Vintage Denim Apparels Ltd. (New building)

Boherarchala, Sreepur, Gazipur-1740.

25 February 2024

Table 3-1: Live Loads provided in the model of the building

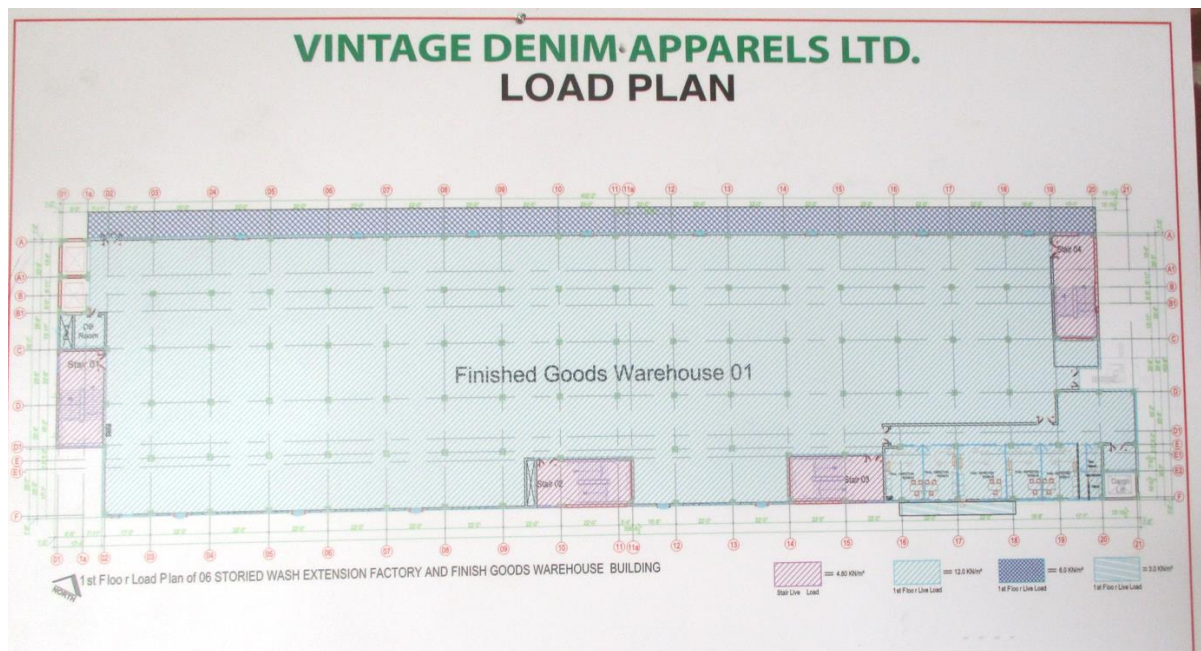
Description: In the design report live load considered as 3, 5, 6 kPa for roof, production, and storage areas respectively. But in the posted load plan we found 3, 6, 12 kPa for roof, production, and storage areas.

Description: In the design report pile capacity considered 80 tons (FoS=2.0) based on soil test report and pile load test. But no pile load test report was found onsite. The building engineer is required to revise the design documents considering the inconsistencies and submit the documents to RSC for review.
